**E6601A-01**

**S E R V I C E N O T E**

**E6601A Wireless Communications Test Set**

**Recover On-Failure (ROF) Program for CISPR 11 radiated emissions test failure.**

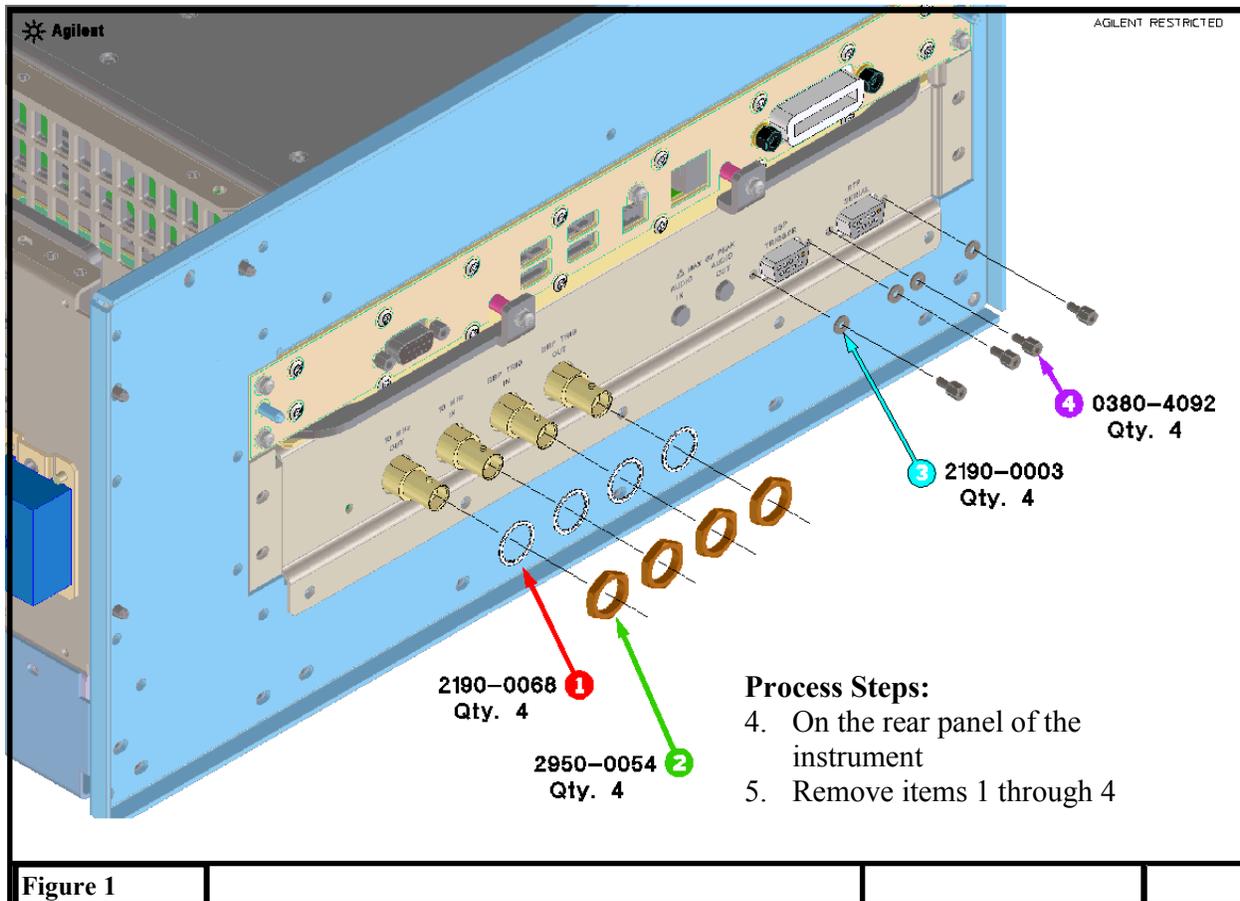
CISPR 11 radiated emissions test failure due to insufficient grounding on the rear panel Audio In and Audio Out connections.

Rear panel connections Audio In and Audio Out require additional grounding. This is accomplished by inserting a conductive washer between the rear panel cover and the audio connectors on the mother board. Figures 1 and 2 show the location of the parts to be installed.

1. If the instrument is turned on, shut the instrument down via the front panel on/off button and unplug the line cord from the instrument.
2. Attach an electrostatic discharge strap to the instrument and take necessary electrostatic discharge precautions.
3. Go to Figure 1 and follow the process steps:
